SOUTH AFRICAN NOTICE TO MARINERS JUNE 2003 EDITION

**PUBLISHED MONTHLY
BY THE
HYDROGRAPHIC OFFICE
CAPE TOWN**

51* SOUTH AFRICA, South Coast - Agulhas Bank - Sable Oilfield.

To accompany Notice to Mariners 51 of 2003

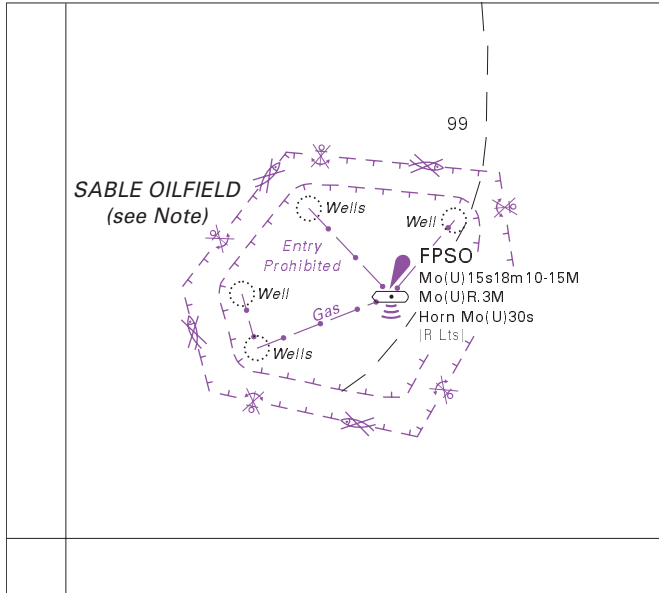
Insert : The accompanying block, showing the Sable Oilfield
in approximate position 35°12'.42 S 021°19'.22 E

Insert : The accompanying block, showing the Sable Oilfield
in approximate position 35°12'.42 S 021°19'.22 E
(SAN 4, 81, 122)
